Standard Military Pattern (SMP) Vehicles Request For Proposal (RFP)

Solicitation No. W8476-06MSMP/J

Amendment # 011

SCHEDULE BA-7-2- S280 / 12' GENERAL PURPOSE SHELTER INTERFACE REQUIREMENTS

Figure 1 SHELTER TIEDOWN INTERFACE REQUIREMENTS

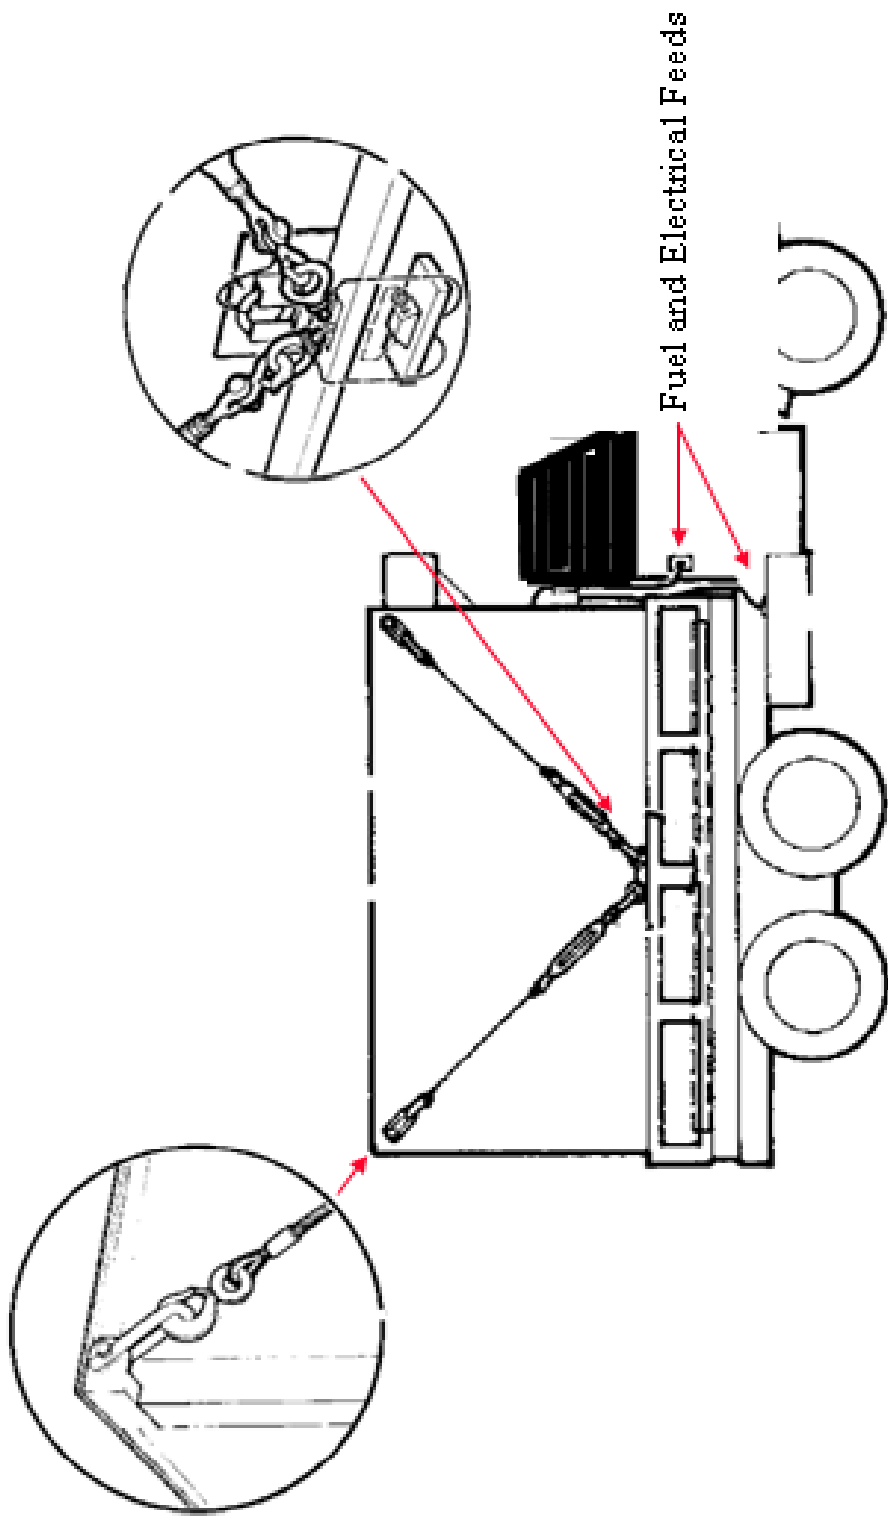
9. At Part 7, Annex B, Appendix BA, Attachment BA-7, ID BA-7-24**Delete:**

" The cargo bed shall be provided with the necessary provisions to allow the installation and operation of the S280 and General Purpose Shelters currently used on the Medium Logistic Vehicle Wheeled (MLVW) cargo variant. The details for installing and removing the shelters are in Section 13 of C-90-010-002/ME-000. Note: that the S280 and General Purpose Shelter installation includes a requirement for a fuel source from the vehicle fuel tank fitted with a quick disconnect and an electrical connector. The tiedown points shall provide the same functionality as the current plate and eyebolt assembly as indicated on DND Dwg 8280008 and shall interface with the cable/turnbuckle system used on the shelters."

Insert :

"The cargo bed shall be provided with the necessary provisions to allow the installation and operation of the S280 and twelve foot General Purpose Shelters currently used on the Medium Logistic Vehicle Wheeled (MLVW) cargo variant. Each Shelter measures approx 3700mm L x 2200mm W x 2300mm H. Shelters are not equipped to accept ISO twist locks therefore a blocking system will have to be provided to restrain the shelters from moving forward, rearward and sideways throughout the Vehicle mobility range and mission profile. The S280 and General Purpose Shelter installation includes a requirement for a fuel source from the vehicle fuel tank fitted with a quick disconnect and an electrical connector. The tiedown points shall provide the same functionality as the current plate and eyebolt assembly as indicated on DND Dwg 8280008 and shall interface with the cable/turnbuckle system currently used on the shelters. For more information refer to Appendix BA- Attachment BA-7 Schedule BA-7-2 "for turnbuckle interface requirements."
